Wayside Elementary School Modernization

## MEETING NOTES

PROJECT NO. :	Schematic Design - Community Meeting #3.5 530275.000		
cc :	Shawn Benjaminson Cindy Ponafala Phill Brummett FILE ATTACHMENTS		
ATTENDEES Yong-Mi Kim Courtney Jones Jenny Kim Lynn Stuart Shelly Yanow Sherri Chester Dana Parks Kevin Zelin Katherine Grosso Carolyn Ader Claire Adams Jenn Lewington Melissa Hardisor Hee-Jin Yoo Andrea Monica Ashlie Arndt Anne Krauss Clare Ritter Wendy Way Maureen Casey	WES - Teacher WES - Teacher WES - Teacher	<u>PHONE</u> 301-279-8484	EMAIL Yong_M_Kim@mcpsmd.org Courtney_M_Jones@mcpsmd.org Im_j_kim@mcpsmd.org Lynn_L_Stuart@mcpsmd.org Rochelle_L_Yanow@mcpsmd.org Sherri_chester@mcpsmd.org Dana_L_Parks@mcpsmd.org Kevin_T_Zelin@mcpsmd.org Katherine_T_Grosso@mcpsmd.org Carolyn t ader@mcpsmd.org Claire_p_adams@mcpsmd.org Jennifer_c_Lewington@mcpsmd.org Melissa_L_Hardison@mcpsmd.org Hee-Jin_Yoo@mcpsmd.org Andrea_n_monica@mcpsmd.org Andrea_n_monica@mcpsmd.org Anne_C_Krauss@@mcpsmd.org MKritter1@aol.com Wendy_beth_way@mcpsmd.org

Project Number 530275 Meeting Notes – Community Meeting #3.5

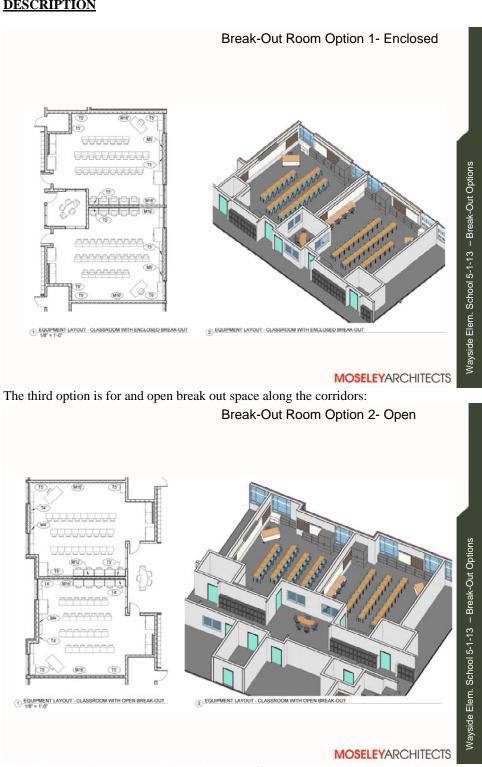
7. Ms. Merlo presented the options for classrooms at Wayside. The first option is to keep the standard -- -classroom layout showing a full 900sf classroom that would be provided if no break-out rooms are desired.

The next slide shows option one for Break-out rooms, a small enclosed room adjacent to classrooms:

The various options were considered by the staff. The current pods are used for three main reasons, first for paraeducators to take small groups of children out of the classroom and work with them separately. Second, for some children to use computer stations set up in the pod areas, and third when classes have small group work sometimes groups are sent into the pod to work and spread out from the classroom. It was decided that only the first of the three current uses for pod space could be

replicated with the small break-out rooms. The closed room would have to include an adult teacher or paraeducator for monitoring and the open space would be very distracting with hallway traffic and noise. However, there will be quite a few enclosed smaller rooms already in the plans that can used as Break-Out rooms to bring small groups of children to. Also the amount of time that the small rooms would be in use is not enough to justify losing the space out of the classrooms. It was preferred to have connecting doors between classrooms for community support and ease of supervision if one teacher needs to cover two classes. Therefore the staff decided to make all classrooms the full 900sf and no Break-Out rooms are to be provided.

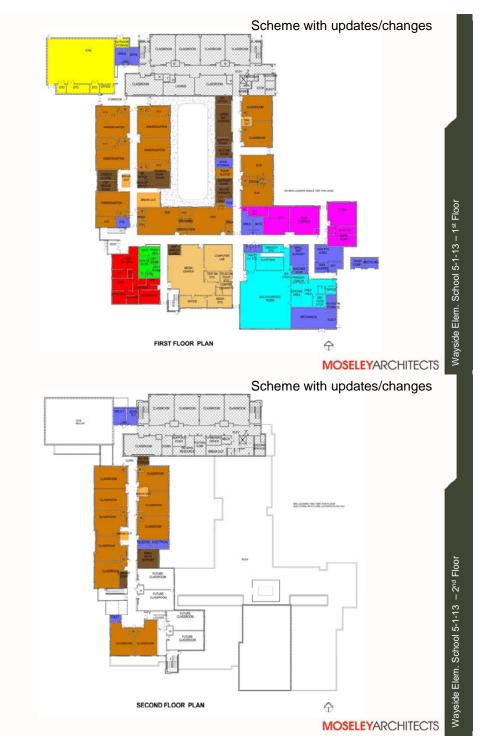
8. The site plan and revised building layout were presented by Ms. Merlo. The Main Entrance for the school has been relocated to the West side of the building facing the parking lot where most of the visitors will be coming from. This allows entrance through a glass vestibule beside an open stair for a welcoming open feel and then the continuation onto the "Main Street" corridor running East West through the front of the building. This corridor would have the light monitors above to bring in natural light. The open stair is possible since the fire stair remains as an emergency exit from the end of the corridor on the second story and exits to the front of the building.
